UNITED STATES PATENT AND TRADEMARK OFFICE

APPLICATION NO). 1	FILING DATE	FIRST NAMED INVENTOR	ATTORNEY DOCKET NO.	CONFIRMATION NO.
10/709,480		05/08/2004	Timothy Kingston	07589.0164.PCUS00	1683
28694	7590	01/12/2005		EXAM	INER
TRACY V			HO, HA DINH		
NOVAK I 1615 L ST		QUIGG LLP		ART UNIT	PAPER NUMBER
SUITE 850)		3681		
WASHING	GTON, DO	20036	DATE MAILED: 01/12/200	5 .

DETAILED ACTION

1. This is the first Office Action on the merits of Application No. 10/709,480 filed on 5/8/04. Claims 1-9 are currently pending.

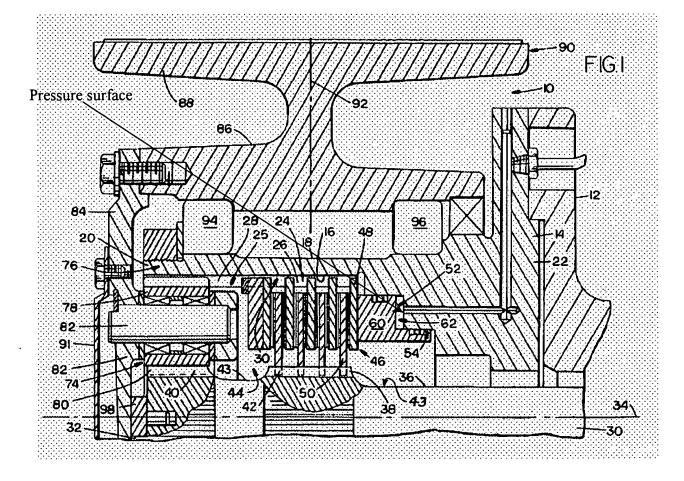
Regarding claim 3, wherein the hub 86 is mounted against the annular member outside in the radial direction of that portion of the annular member which forms the ring gear 76, and also against said portion.

Regarding claim 4, Jirousek et al show the bearing arrangement including two bearings.

The modified wheel hub arrangement would have two rows of balls arranged at a mutual spacing in the axial direction of the driving axle.

Regarding claim 5, wherein the annular member forms a pressure surface (see the Fig. below) for said braking device.
